**Application for Permission under Section 16 of the Town Planning Ordinance (Cap.131)
Proposed Temporary Open Storage of Vehicles and Construction Materials with Ancillary Office and
Associated Filling of Land for a Period of 3 Years at
Lots 1512, 1513 S.A, 1513 S.B, 1513 RP, 1514 S.A, 1514 S.B, 1514 RP, 1515, 1516 and 1632 in D.D. 107 and
Adjoining Government Land, Fung Kat Heung,
Yuen Long, New Territories
(Planning Application No. A/YL-KTN/1159)**

Submission of Further Information 3

**Drainage Impact Assessment
(Section 16 Planning Application No. A/YL-KTN/1159)**

Site Photos taken on 31 October 2025

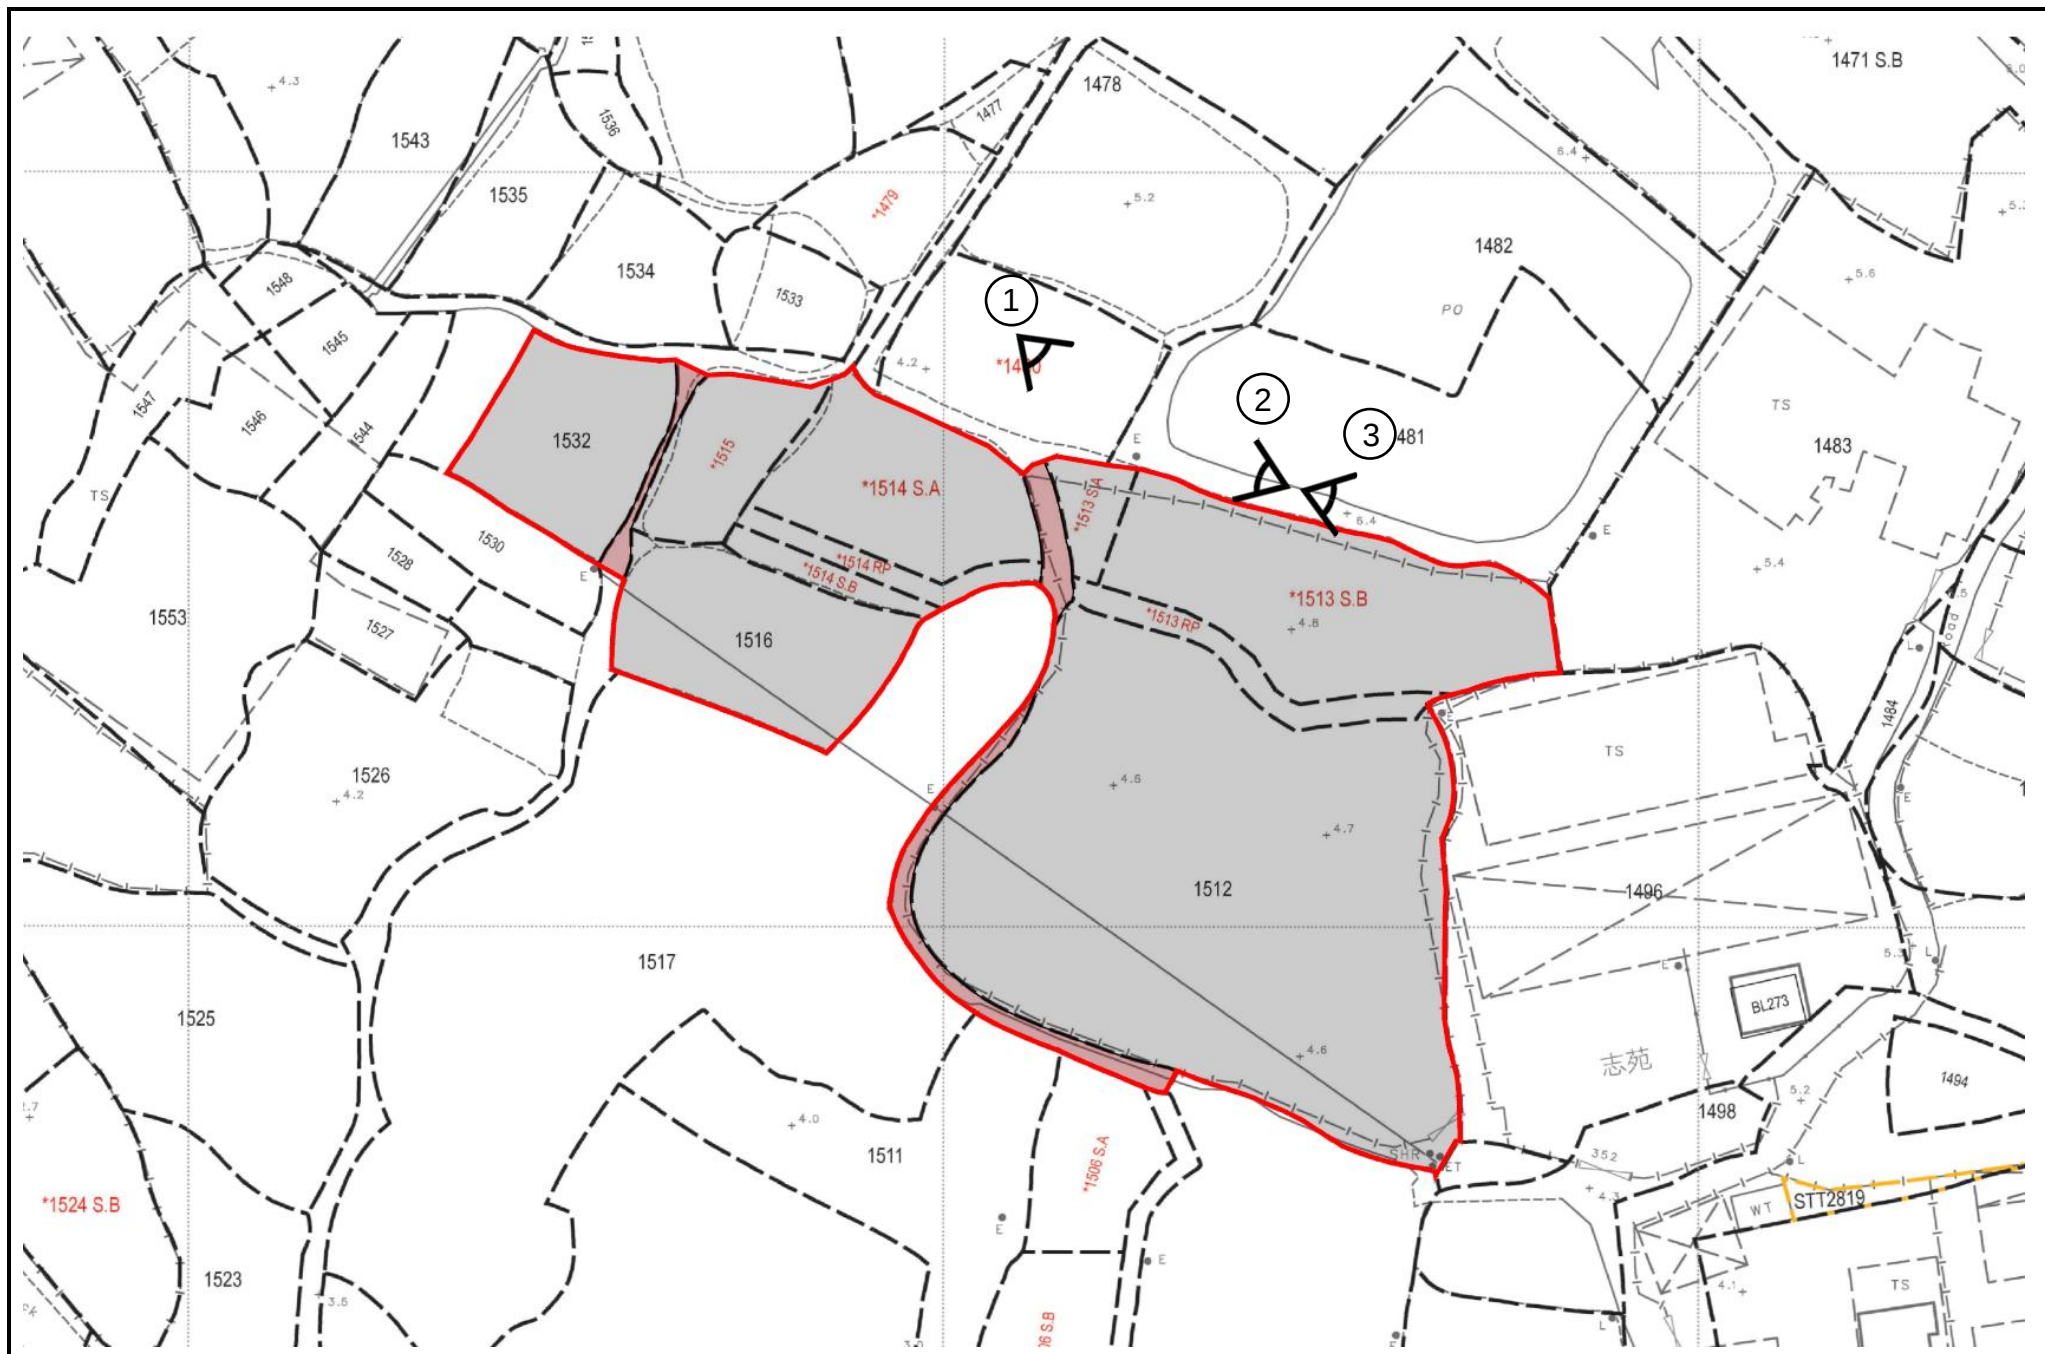
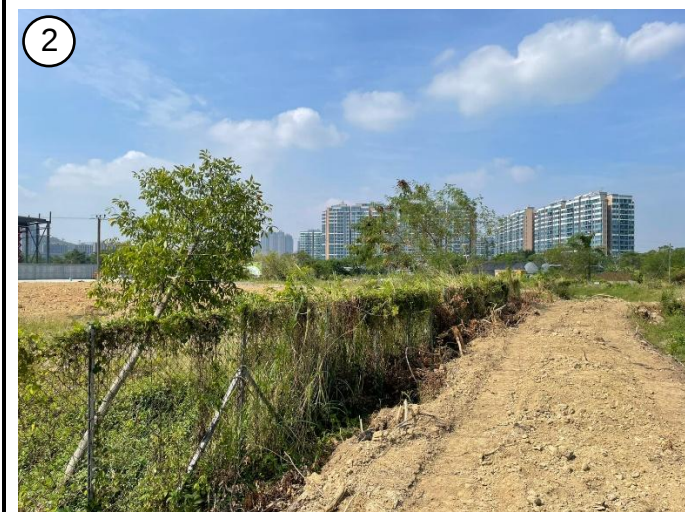
Regarding the tree group situated between the application site (i.e. Lot 1513 S.B) and the adjacent Lot 1481 in D.D. 107, a site visit conducted on 31 October 2025 revealed that there was site works in Lot 1481 which intruded into Lot 1513 S.B (**Attachment 1**). The concerned tree group was unexpectedly affected. To the applicant's understanding, the workers mistakenly recognized the current fencing as the lot boundary and trespassed into the application site. As a result, the applicant has no choice but to admit that he is unable to record the exact location, species and condition of the concerned tree group.

To compensate the tree loss caused by this unanticipated event, the applicant undertakes to plant 10 more trees along the northern boundary of the site. The total no. of new trees planted is increased to 15. Please refer to **Attachment 2** for the revised landscape proposal. In conjunction with this, the total hard-paved area for the proposed development will be further reduced to about 7,552m². Relevant updated documents are at **Attachments 3 to 4** to reflect the proposed changes. For the updated DIA at **Attachment 5**, it is to rectify the discrepancies between the report and the current development proposal, and there is no change in assumption and conclusion.

Revised Filling of Land Plan

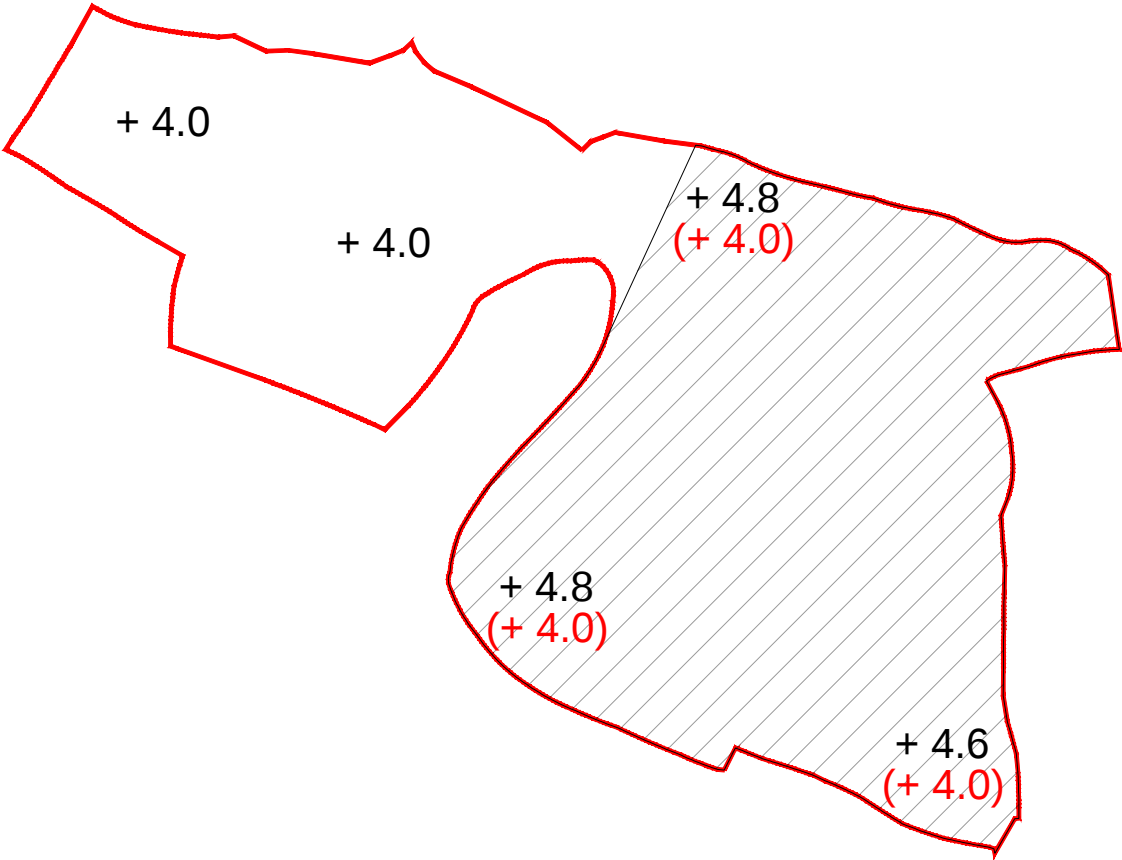
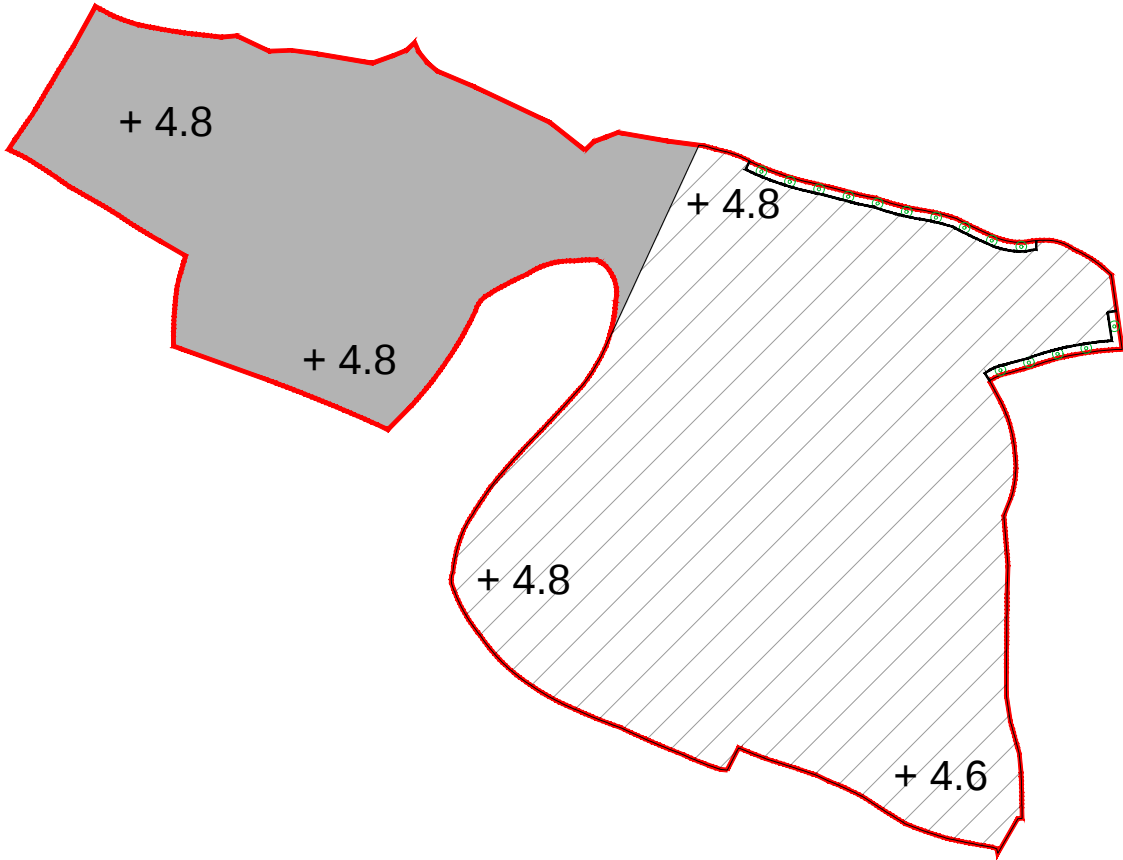
- Attachment 1** - Site Photos taken on 31 October 2025
- Attachment 2** - Revised Landscape Proposal
- Attachment 3** - Replacement Page of Application Form
- Attachment 4** - Revised Filling of Land Plan
- Attachment 5** - Updated Drainage Impact Assessment (DIA)

APPLICATION SITE AREA : 7,627 m² (ABOUT)
PROPOSED PLANTER AREA : 75 m² (ABOUT)
TOTAL HARD-PAVED AREA : 7,552 m² (ABOUT)
EXISTING HARD-PAVED SURFACE AREA : 4,865 m² (ABOUT)
PROPOSED FILLING OF LAND AREA : 2,687 m² (ABOUT)
PROPOSED LAND FILLING DEPTH : NOT MORE THAN 0.8 m
PROPOSED SITE LEVELS : +4.0 mPD TO +4.8 mPD
MATERIAL OF FILLING FOR SITE FORMATION : SOIL WITH CONCRETE AND ASPHALT
